## Interview Summary

Examiner Derek Chapel and I (Bernhard Bausenwein) discussed the claim 31 (the independent, generic claim of the disclosure). This claim relies strongly on the definition of the polarizing layer vectors  $V_i$ , and certain planes derived from  $V_i$ . I stated that the final rejection, OA dated 7.7.2010, is based on a misconception of these polarizing layer vectors, and I also pointed out the fact that the prior art needed additional polarization rotating components (wave-plates) to achieve what our disclosure achieves simply with the polarizing beam splitting layers.

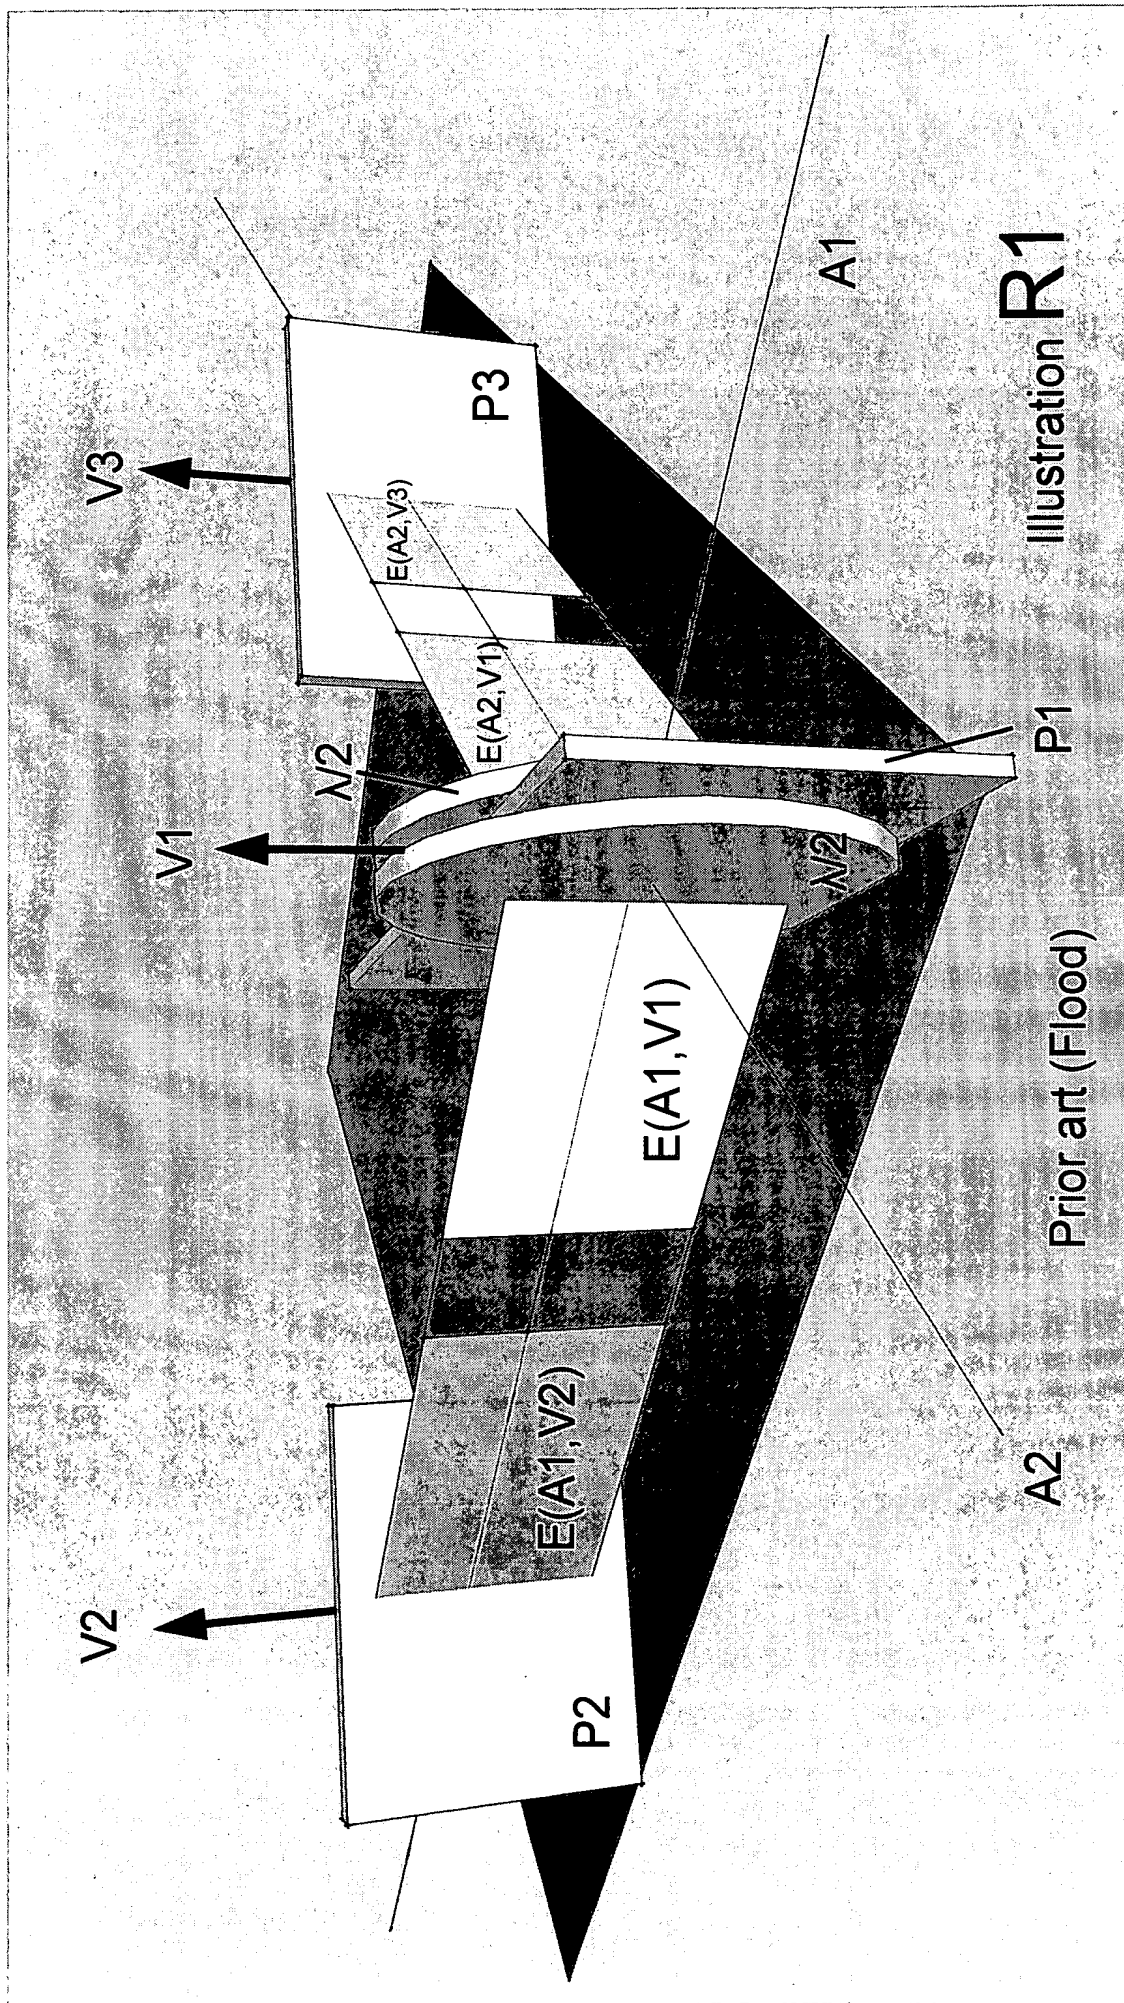
Illustration R1 of this response shows the vectors in the prior art of Flood (US2,449,287). The plane of incidence (POI) is parallel to the indicated ground plane of the planar arrangement. We have included the ground plane in the drawing, because the prior art of Flood and the prior art of Fulkerson et al. (US6,490,087) show arrangements of multiple polarizers in a planar arrangement. A beam, incident on the optical axis  $A1$  is split at  $P1$  such that a sub-beam with a certain polarization ("S") is reflected by  $P1$ , and a beam with the "complementary" polarization ("P") is transmitted

by the polarizer. The "S" polarized beam has its Plane of Polarization (POP) perpendicular to the POI or ground plane of the arrangement, the "P"-polarized beam has its POP parallel to the POI.

$V_1$  equals  $V_2$  equals  $V_3$  in the prior art described by Flood. Without the wave-plate between  $P_1$  and  $P_3$ , the "S"-polarized sub-beam reflected at  $P_1$  into the axis  $A_2$  onto the polarizer layer  $P_3$ , would again (as "S" polarized beam) be reflected by  $P_3$ . Only by the addition of the wave-plate (half wave-plate), the reflected "S"-polarized beam will be transformed into a "P"-polarized beam by a rotation of its POP. This now converted "P"-polarized beam will, however, not be reflected by  $P_3$  but will be transmitted, because  $V_3 = V_1$ ).

The same holds true for the initially "P"-polarized sub-beam. Without the wave-plate between  $P_1$  and  $P_2$ , the "P"-polarized sub-beam transmitted at  $P_1$  along the axis  $A_1$  onto the polarizer layer  $P_2$ , would again (as "P" polarized beam) be transmitted by  $P_2$ . Only by the addition of the wave-plate (half wave-plate), the transmitted "P"-polarized beam will be transformed into a "S"-polarized beam by a rotation of its POP. The "S"-polarized beam will, however, not be transmitted by  $P_2$  but will be transmitted, because  $V_2 = V_1$ .

The plane spanned by  $V_1$  and  $A_1$  [ $E(V_1, A_1)$ ] and the plane spanned by  $V_2$  and  $A_1$  [ $E(V_2, A_1)$ ] are parallel/equal in the prior art of Flood (because  $V_1 = V_2$ ).

The plane spanned by  $V1$  and  $A2$  [ $E(V1,A2)$ ] and the plane spanned by  $V3$  and  $A2$  [ $E(V3,A2)$ ] are also parallel/equal in the prior art of Flood (because  $V1=V3$ ).

Illustration R1 of this response shows very clearly that  $V_1$  as defined by us equals  $V_2$  in Flood, and therefore the plane spanned by  $A_1$  and  $V_1$  is the same (or at least parallel) to the plane spanned by  $A_1$  and  $V_2$ .

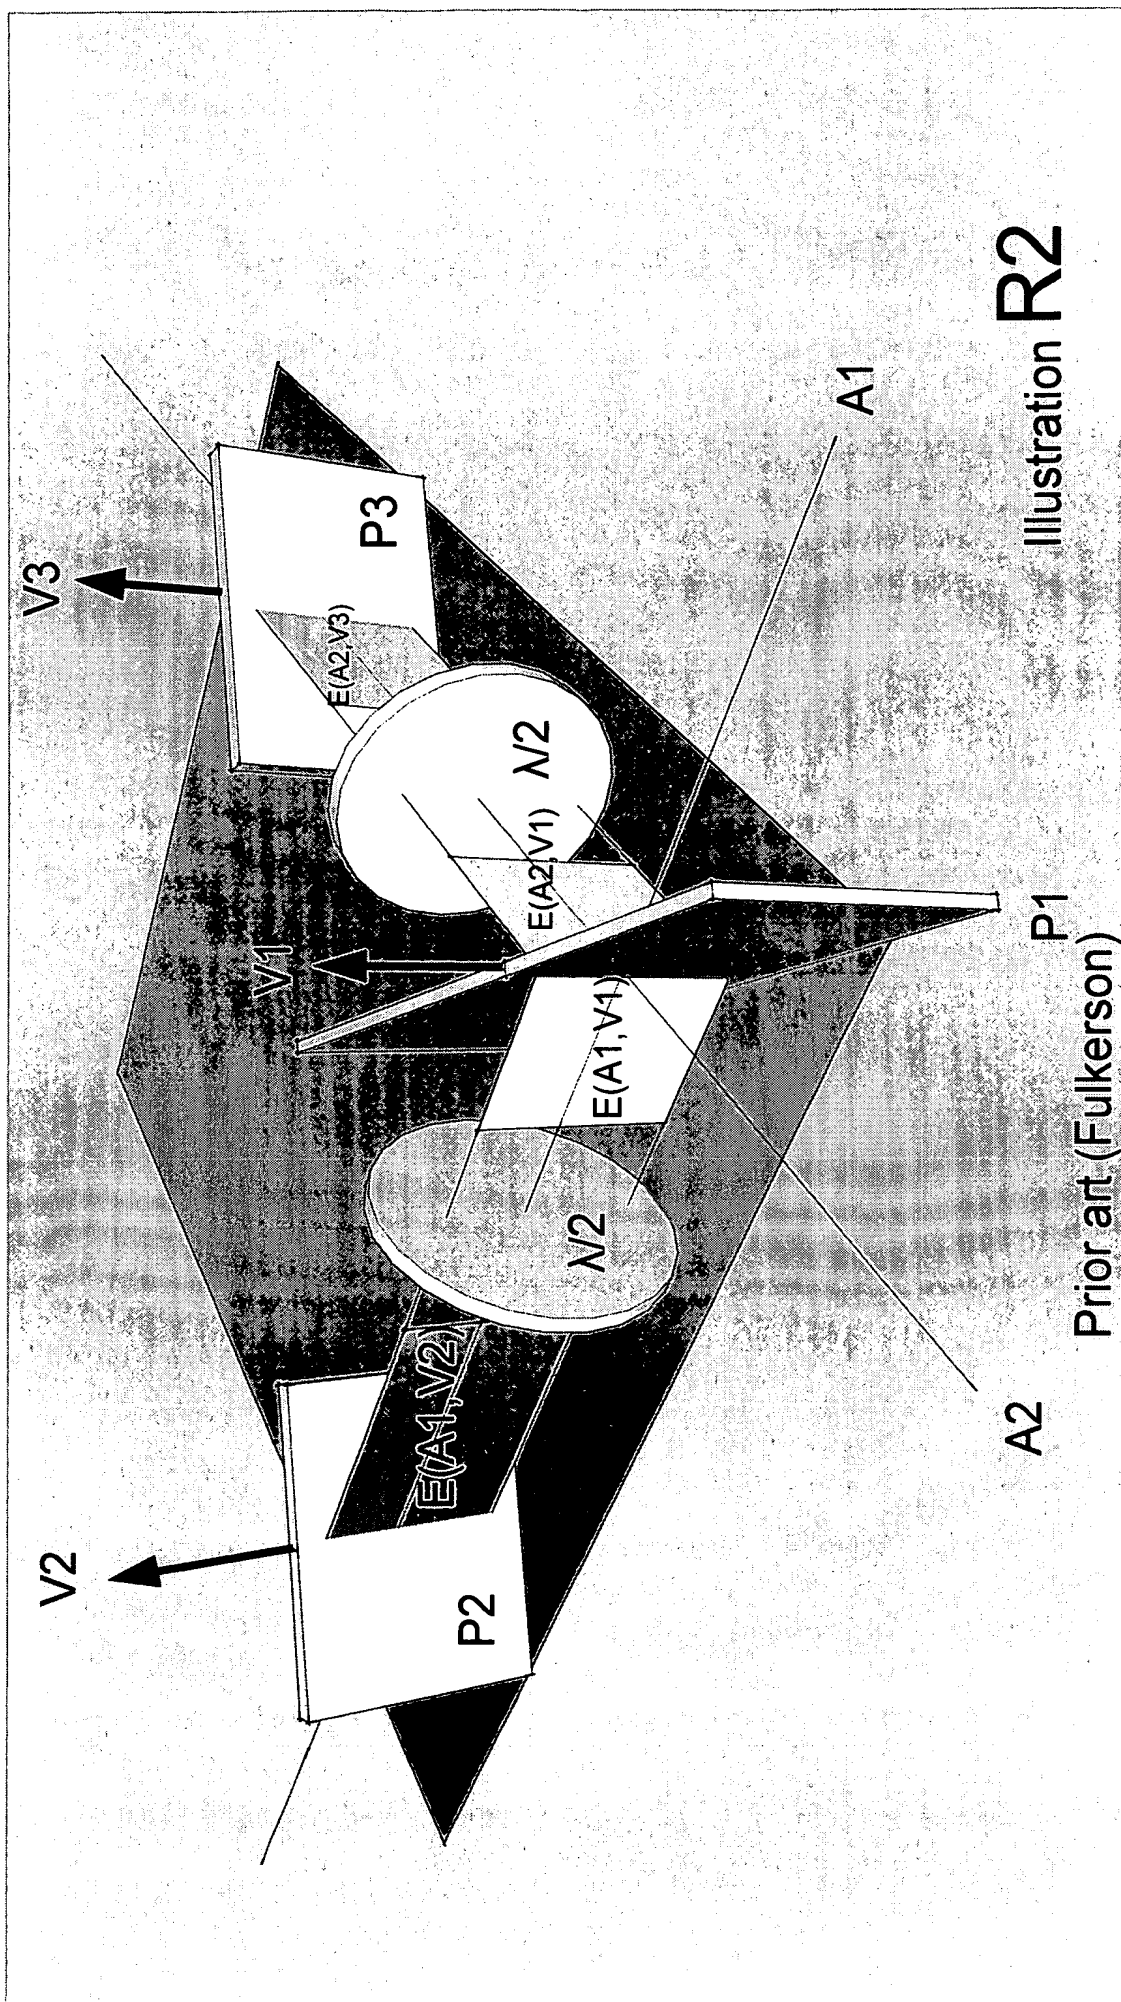
The illustration R2 of this response shows the vectors and planes of the prior art of Fulkerson, who also employs one wave-plate in the arrangement between  $P1$  and  $P2$  and one wave-plate between  $P1$  and  $P3$ . With respect to polarizing layer vectors  $V_i$  and planes, there is no difference between the prior arts of Flood and Fulkerson; both rely on the use of wave-plates; the complex polarizers would not work in the described way without the polarization rotating components. The mathematical relations are identical to those of Flood, and indicated below the drawing.

Polarizing layer vectors:  $V1=V2=V3$ ; all  $V \perp$  ground plane (plane of incidence)  
 Planes:  $E(A1, V1) = E(A1, V2)$ ;  $E(A2, V1) = E(A2, V3)$   
 The wave-plates ( $\lambda/2$ ) have no influence on the geometry of  $V_i$  and derived planes  $E$ .

Cross polarizer: general case

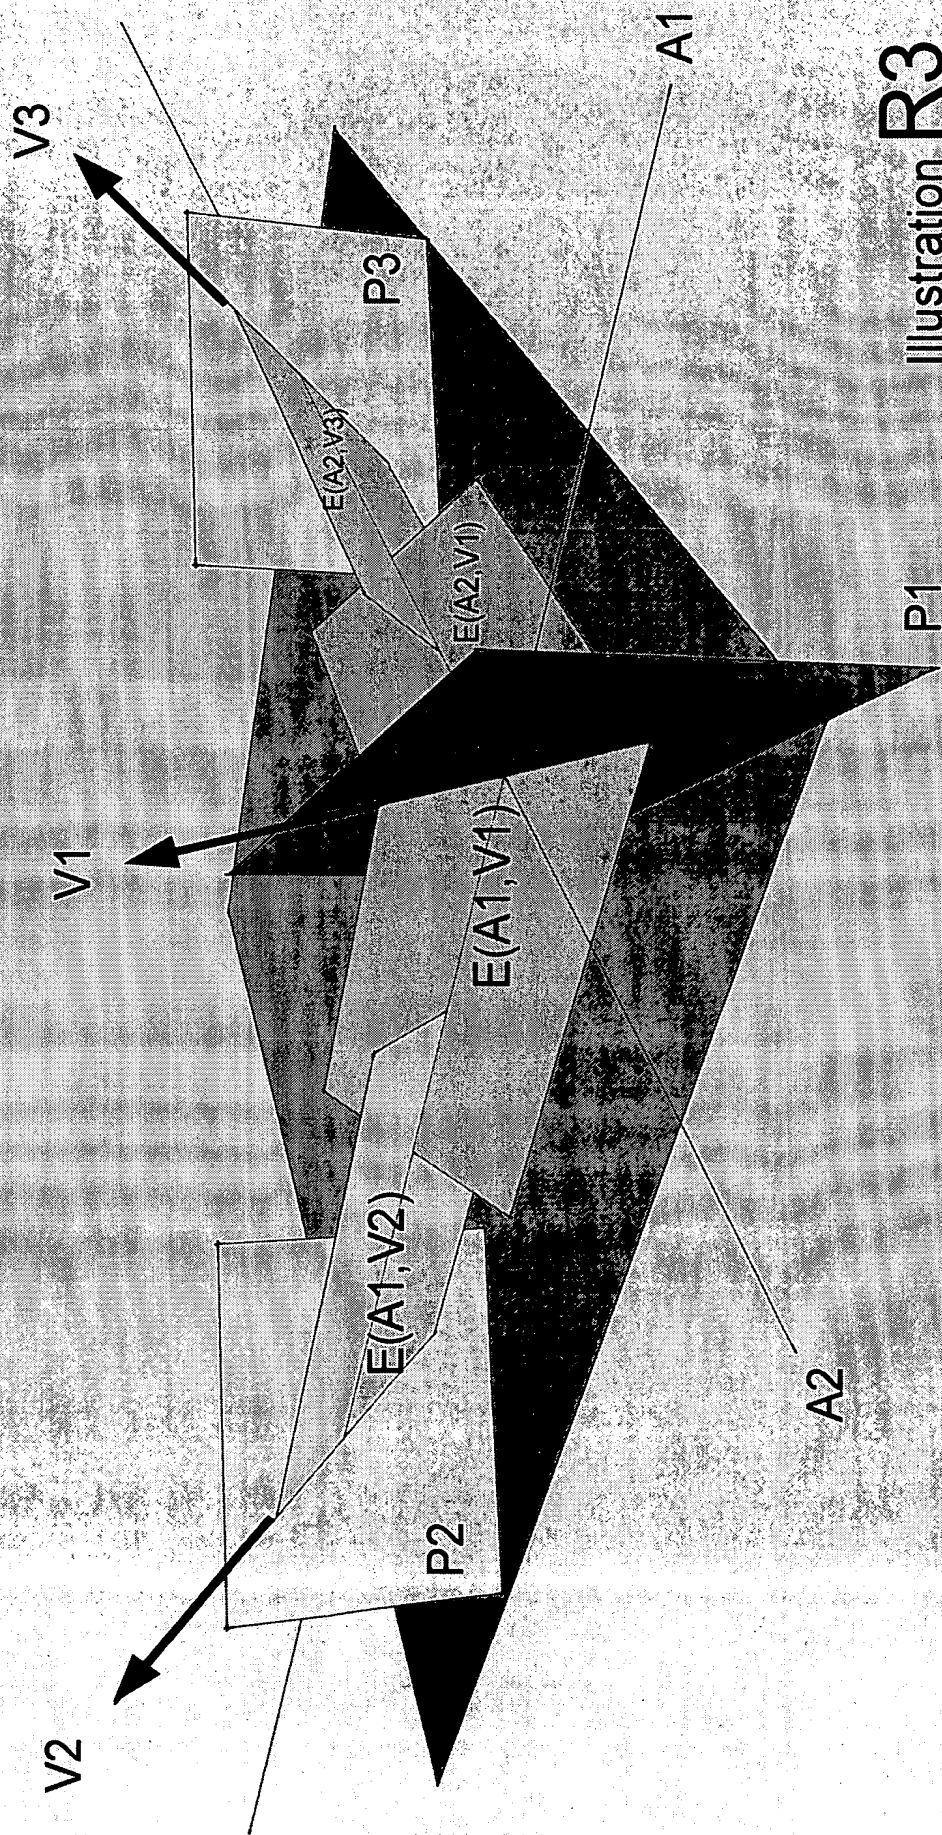
Illustration R3 of this response shows the most general case of our invention.  $V1$  is not necessarily orthogonal to the plane of incidence. (Imagine  $V1$  to be parallel to the orientation of wire grids on the polarizer  $P1$ ).

Now, and this is the important step,  $V3$  is chosen such that the sub-beam reflected at  $P1$  is transmitted by  $P3$  without polarization rotating components between  $P1$  and  $P3$ ; and  $V2$  is chosen such that the sub-beam transmitting  $P1$  is reflected at  $P2$  without polarization rotating components between  $P1$  and  $P2$ . This results with a very special relation of the planes spanned by the optical axes and the polarizing layer vectors:

In our invention the plane spanned by  $V1$  and  $A1$  [ $E(V1,A1)$ ] is perpendicular to the plane spanned by  $V2$  and  $A1$  [ $E(V2,A1)$ ].

In addition, the plane spanned by  $V1$  and  $A2$  [ $E(V1,A2)$ ] is perpendicular to the plane spanned by  $V3$  and  $A2$  [ $E(V3,A2)$ ].

Polarizing layer vectors:  $V1 \neq V2$ ;  $V1 \neq V3$ ;

Planes:  $E(A1, V1) \perp E(A1, V2)$ ;

$E(A2, V1) \perp E(A2, V3)$ ;

Illustration R4

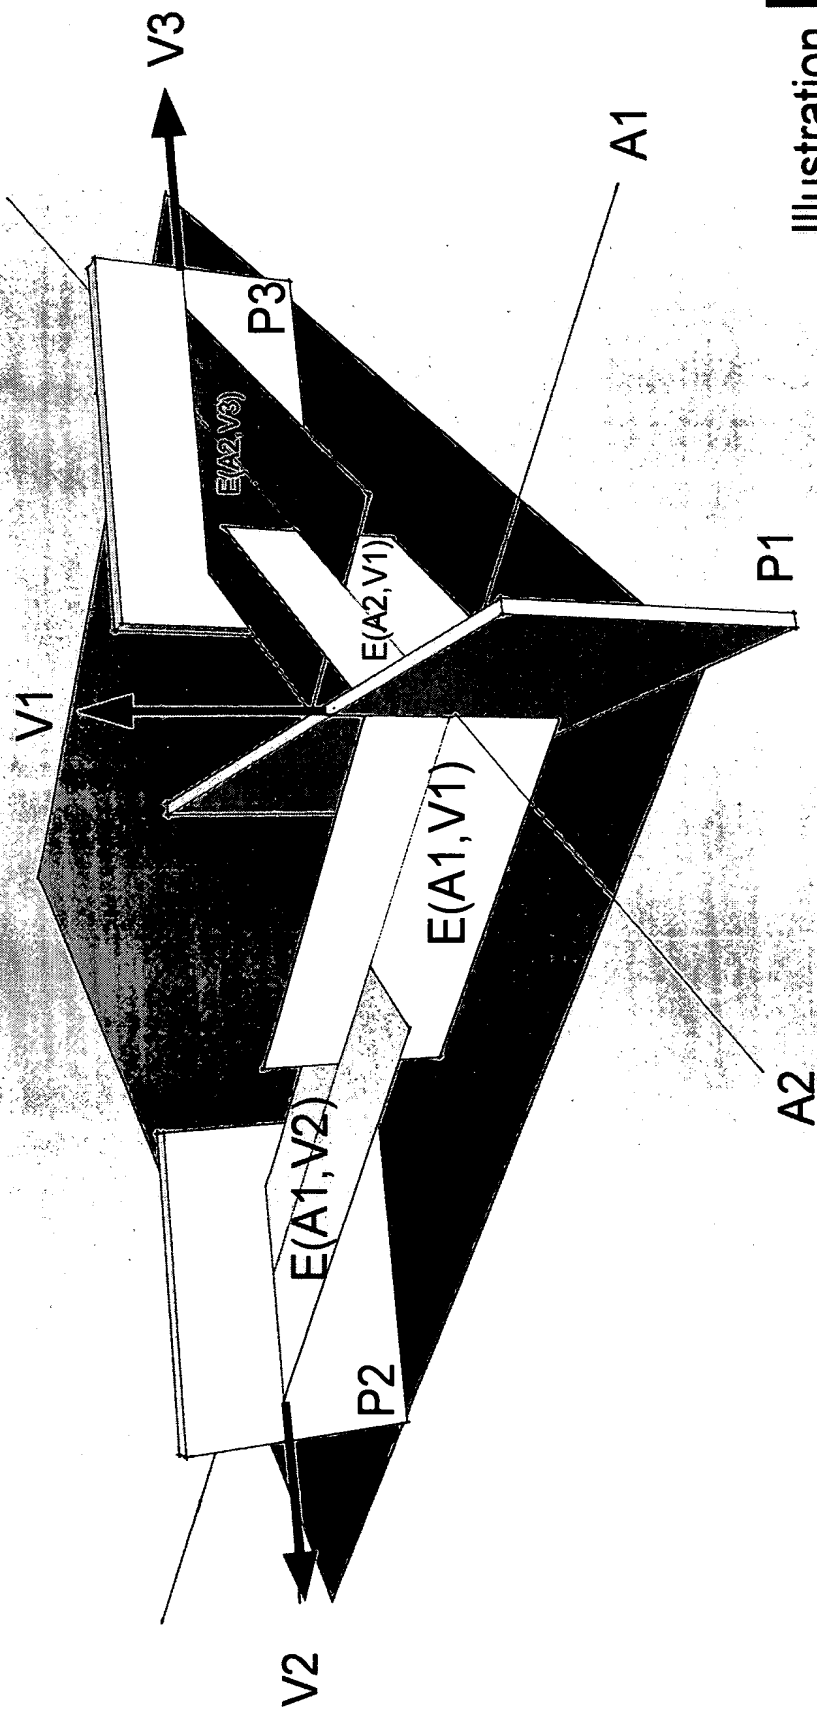
Illustration R4 shows a special case of our invention, and was mainly included because of a remark made in the OA on page 5, under Claim Objections 10 d. (See detailed actions taken). It is also interesting because  $V_1$  has been chosen to be  $V_1$  of the prior art, which again sheds quite some light on the differences of our invention from the prior art.

If  $V_1$  is chosen to be  $V_1$  of the prior art (compare illustrations R1, R2 of this response) to be perpendicular to POI ( or ground plane). We call this the orthogonal case ( $V_1$  could also be chosen to be parallel to POI), this has several profound effects:  $V_2$  and  $V_3$  will then, as shown in illustration R4, be parallel to the ground plane (moreover, it is possible that  $V_2$  equals  $V_3$ ).  $V_2$  and  $V_3$  will, only in this special orthogonal cases, be perpendicular to  $V_1$ .

Cross polarizer: special orthogonal case:

Polarizing layer vectors:  $V1$  is chosen to equal  $V1$  as determined in prior art:

$$V1 \perp V2; V1 \perp V3 \text{ (different from prior art!)}$$

Planes:  $E(A1, V1) \perp E(A1, V2);$

$E(A2, V1) \perp E(A2, V3);$

OA10) All informalities but 10d, were amended following the suggested corrections. The interpretation of the examiner in 10d is incorrect, and the notion is an important special case of the invention. We have provided the illustration R4 to show this special case. The end of the claim 21 thus still reads: V2 being perpendicular to V1.
